ADDITIONAL PRELIMINARY
SOIL AND FOUNDATION INVESTIGATION
PROPOSED 6, 7, AND 9-STORY APARTMENT STRUCTURES,
AND 2-STORY PARKING STRUCTURES
HUI IWA STREET
KANEHOHE, OAHU, HAWAII
W. O. 414-00 APRIL 25, 1973

Subject: Review of Proposed Slope
Vista Garden, Multi Level Apartments

- Reference:
1. Grading and Drainage Plan
Prepared by Gray, Rhee & Associates
 2. Preliminary Soil Reports dated September 28, 1972
and April 25, 1973, W. O. 414-00 by Geolabs

Subject: Additional Preliminary Soil and Foundation
Investigation
Proposed 6, 7, and 9-Story Apartment Structures
and 2-Story Parking Structures
Hui Iwa Street, Kaneohe, Oahu, Hawaii

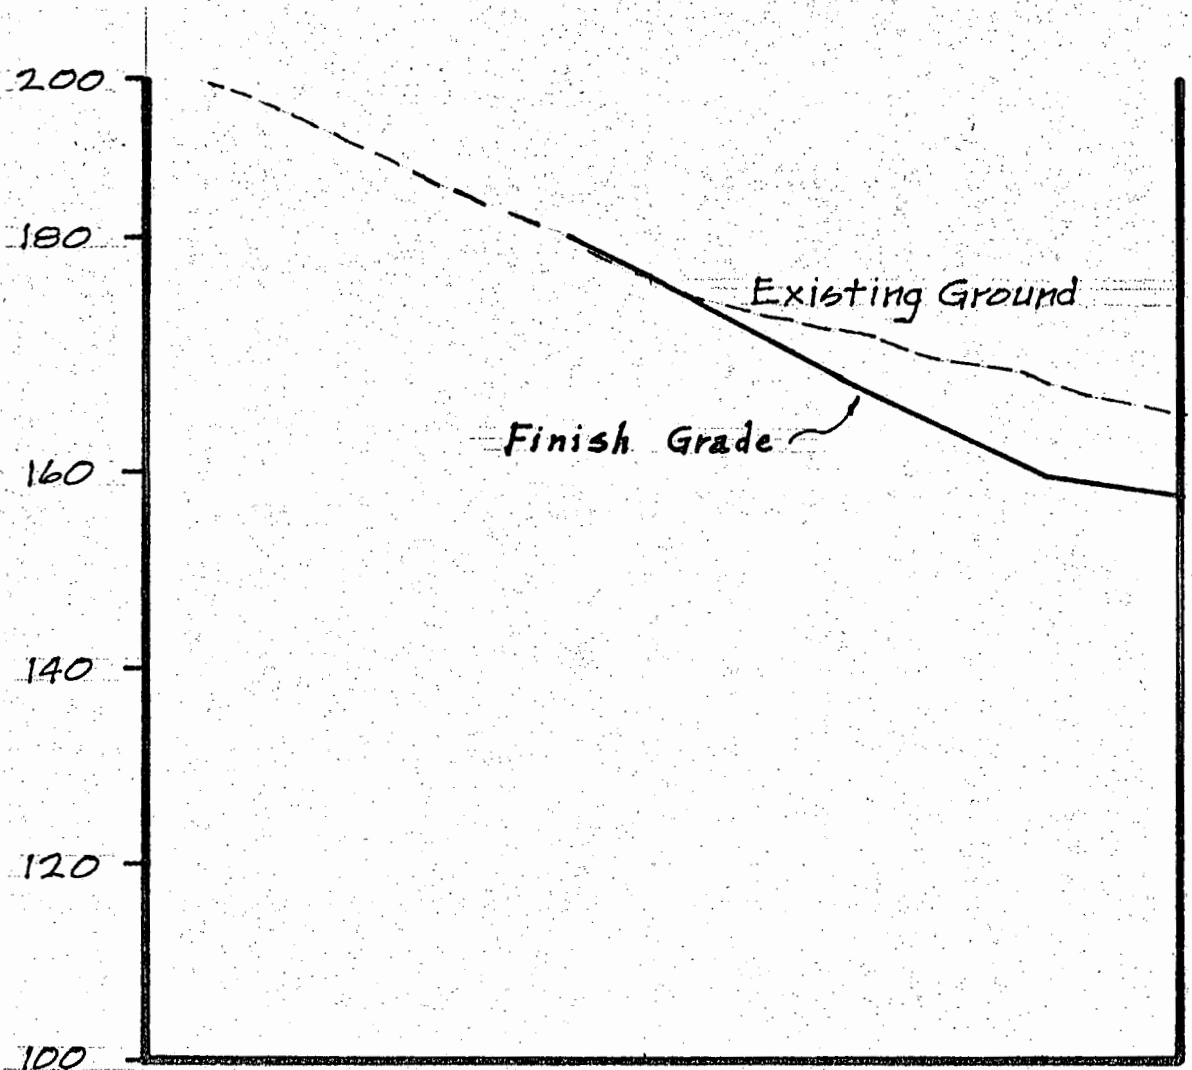
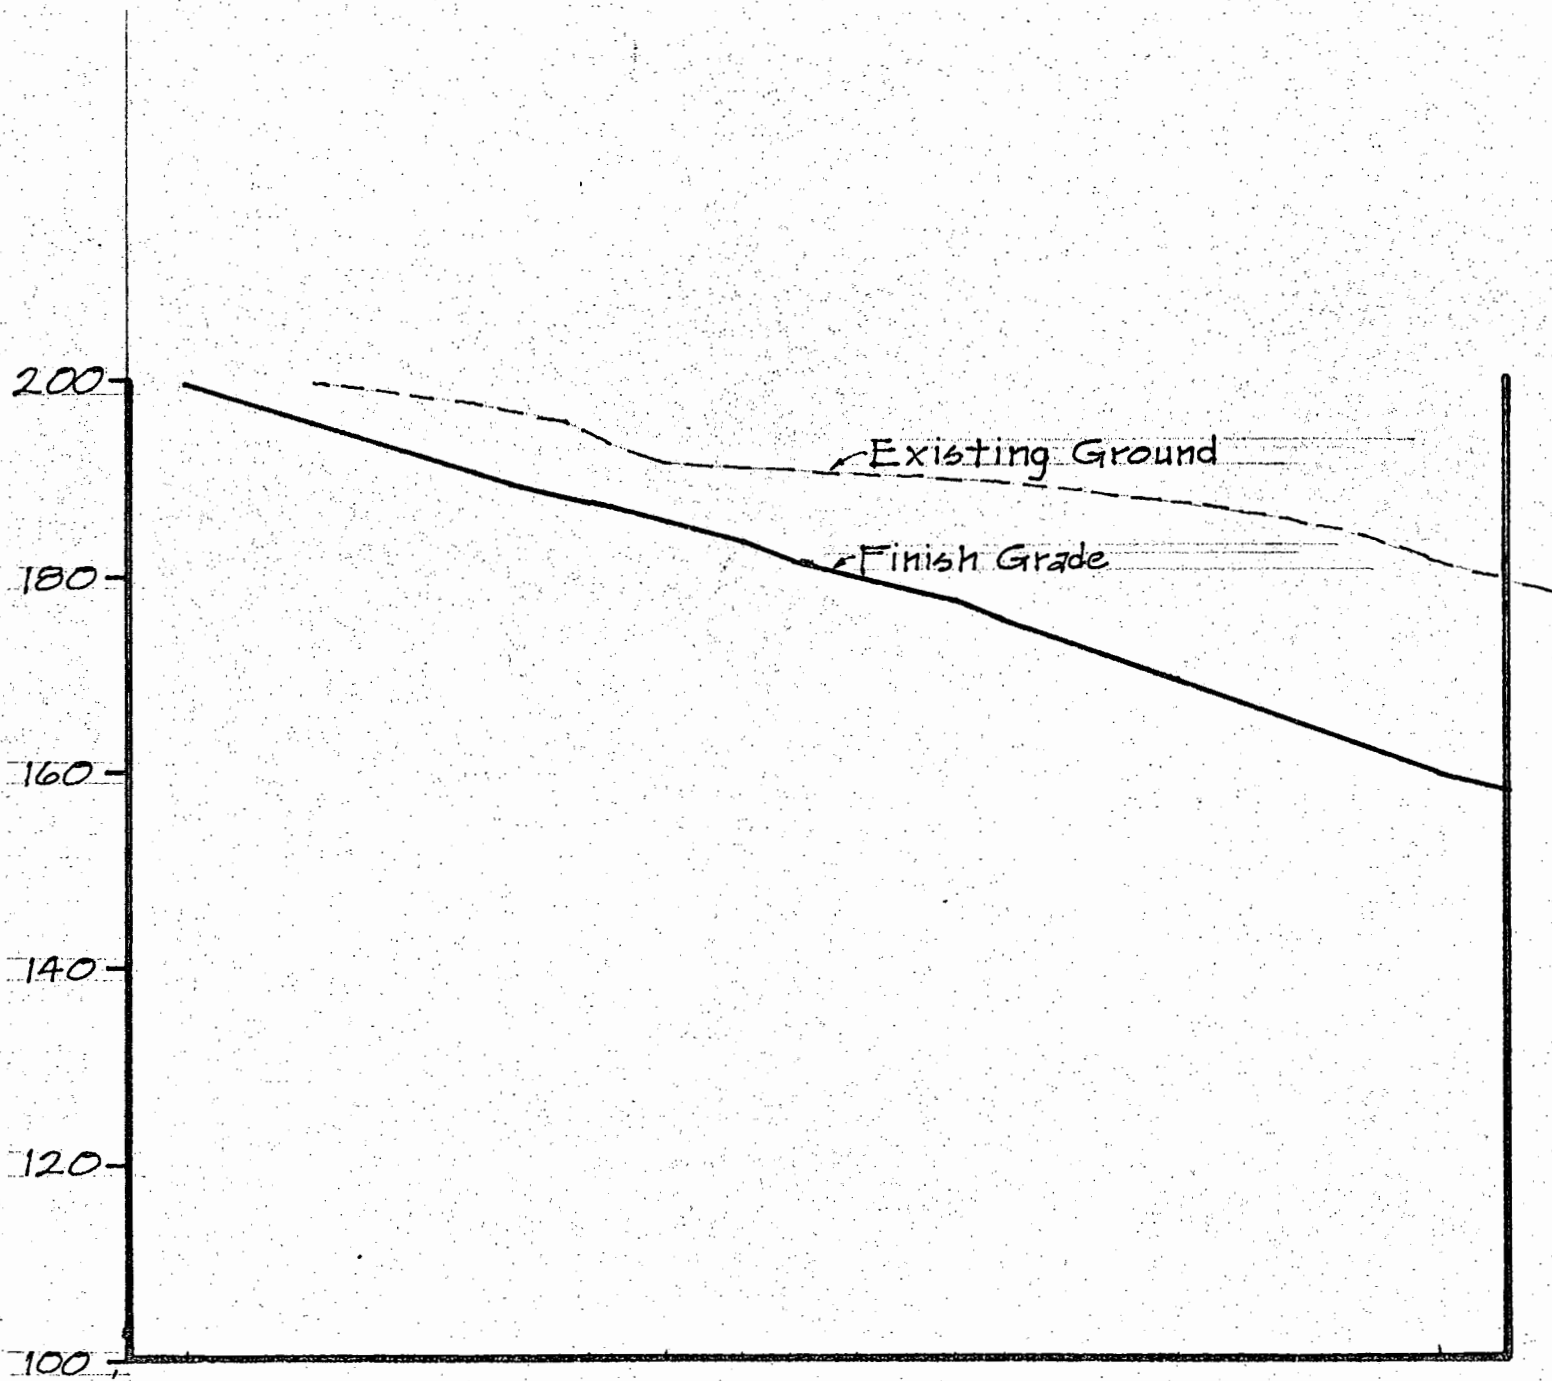
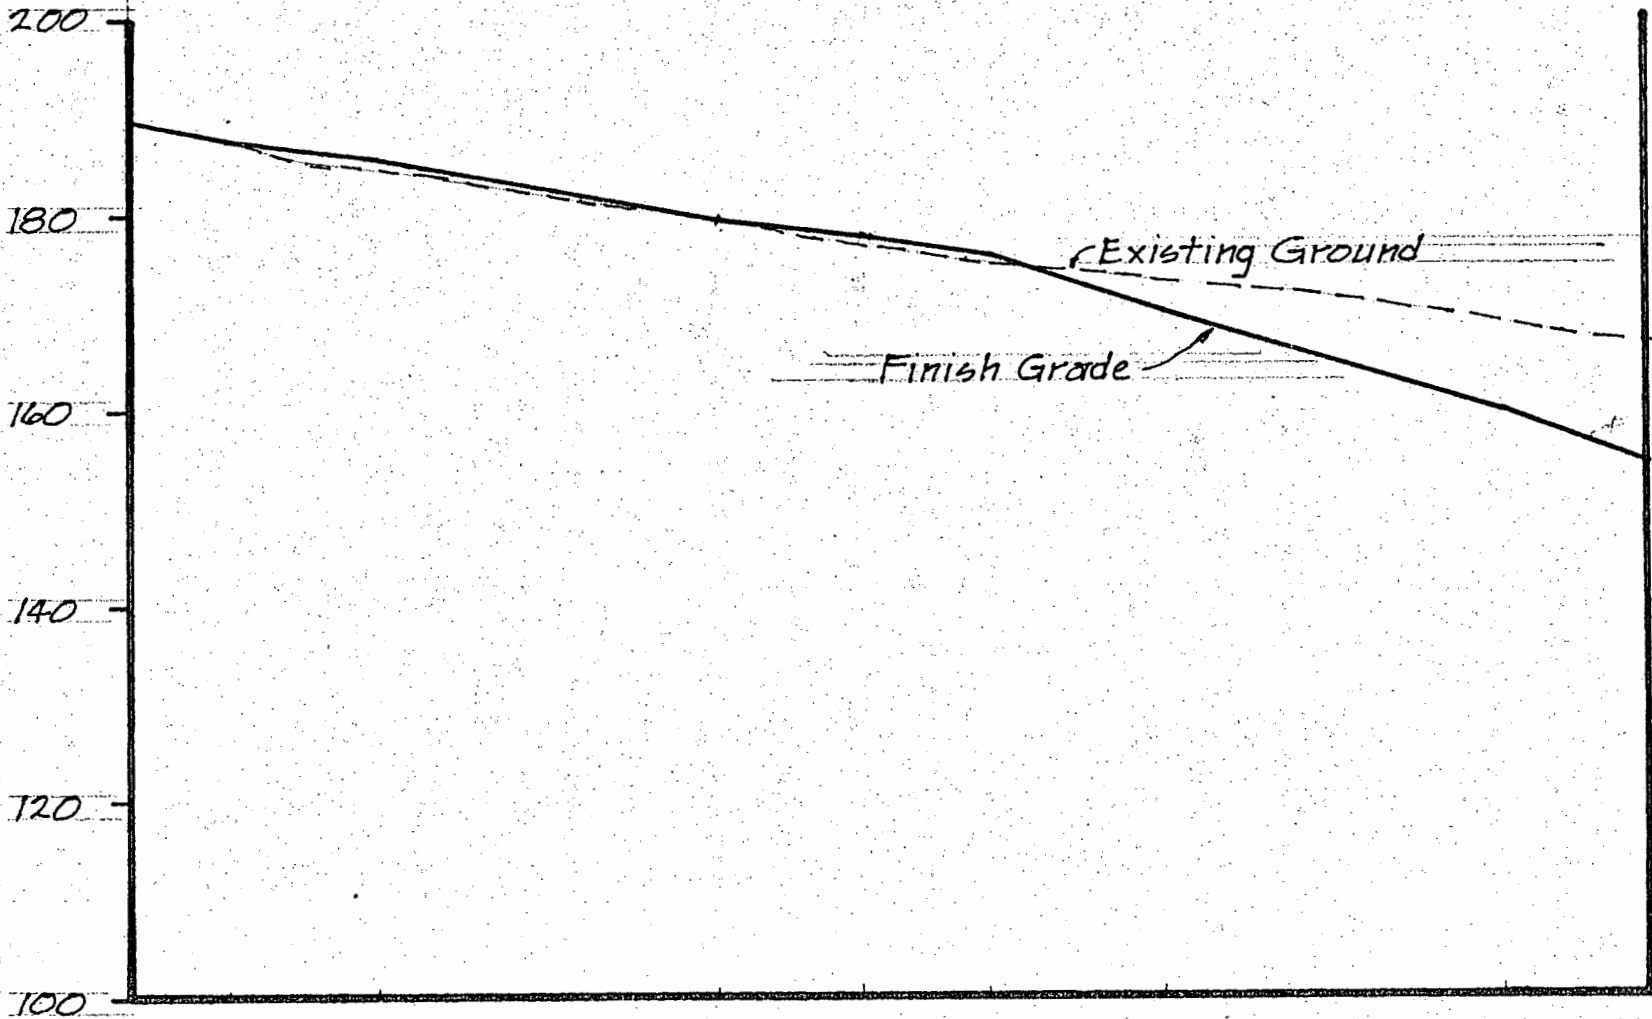
At the request of your engineers, Gray, Rhee & Associates, Inc., this firm has reviewed the proposed slope to the southwest of the referenced project. The slope is proposed at a gradient of 2 horizontal to 1 vertical (2:1) with no benches. The maximum height of the slope is about 40 feet of which the lower 20 feet will be cut while the upper 20 feet will be natural slope whose gradient is very close to 2:1. There will be some thin fills placed in a very small gully towards the southern portion of the slope. These thin fills (and all fills placed on slopes steeper than 5:1) should be well keyed in to natural ground. Since this is a small gully originating locally, we anticipate that a subdrain will not be necessary. However this opinion should be confirmed during grading.

It is our opinion that the proposed slopes would be grossly stable provided that the surface erosion is controlled. This opinion is based upon on the assumption that the materials in the cut slope will be at least equivalent to the ones encountered in nearby borings. This should be confirmed during grading.

As per our discussion with Mr. Rhee, the grading ordinance requires 8 feet wide benches at vertical intervals of 15 feet on the slopes. There are two primary purpose of these benches. One is to provide additional gross

stability to the slope and second is to provide proper drainage for erosion control. It is our opinion that since the slopes would be grossly stable as proposed, benches are not necessary to obtain additional gross stability. However, this area being under relatively intense rainfall zone, a well planned and maintained drainage system would be required for erosion control. Benches with concrete lined drainage ditches may be used as a part of the drainage system for erosion control.
